N1030B-01

Information Only Service Note

N1030B 65 GHz Dual Channel Optical Module

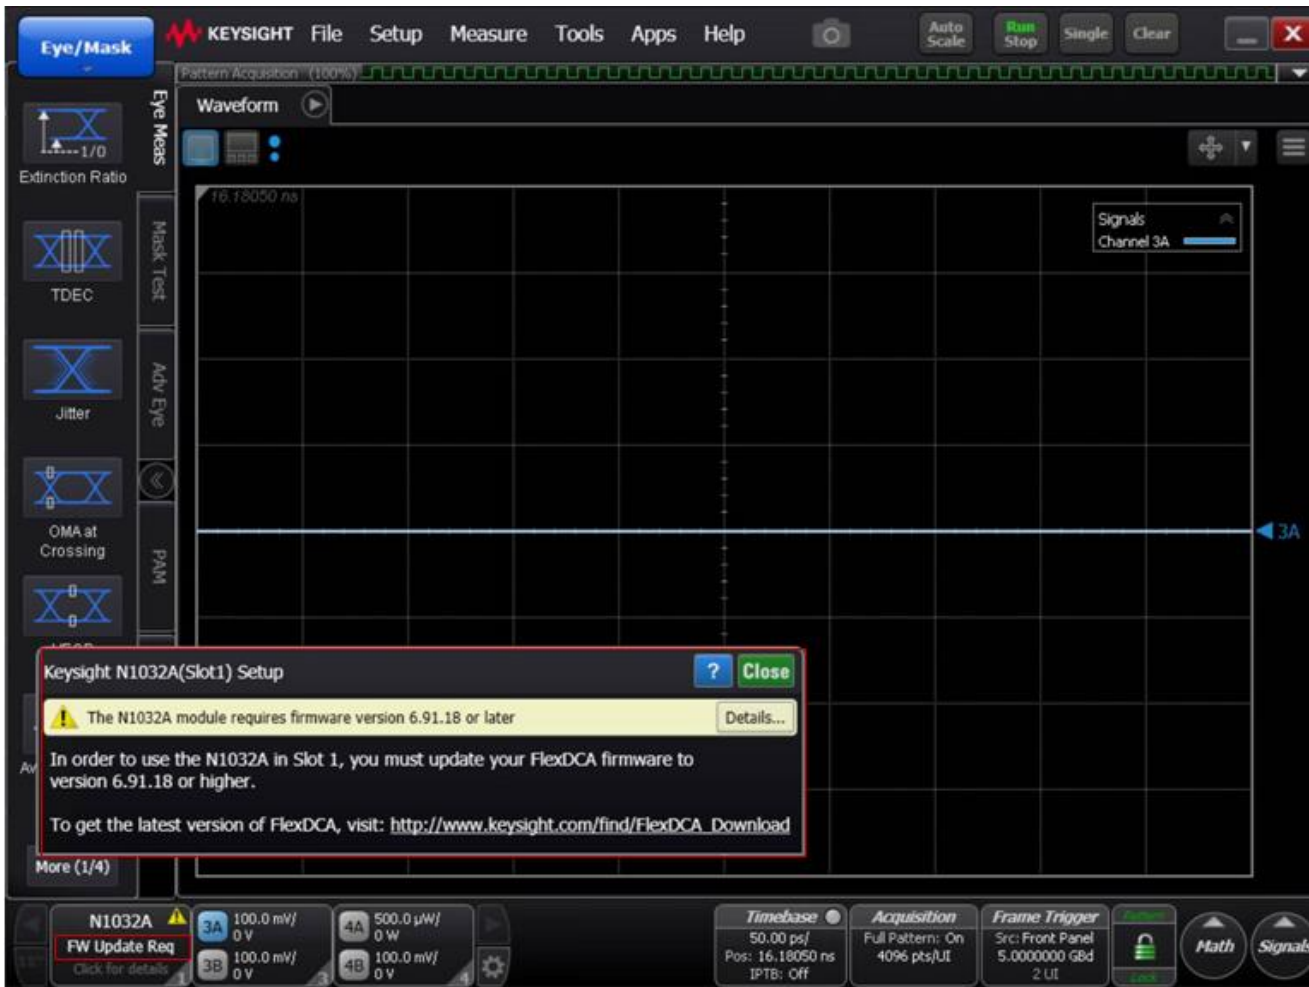
With the module installed in a DCA mainframe, if a message like the one below is displayed, FlexDCA must be updated to the indicated version (or later):

To update FlexDCA software, download from www.keysight.com/find/flexdca_download and install. While only the indicated version is required, updating to the latest version is recommended.
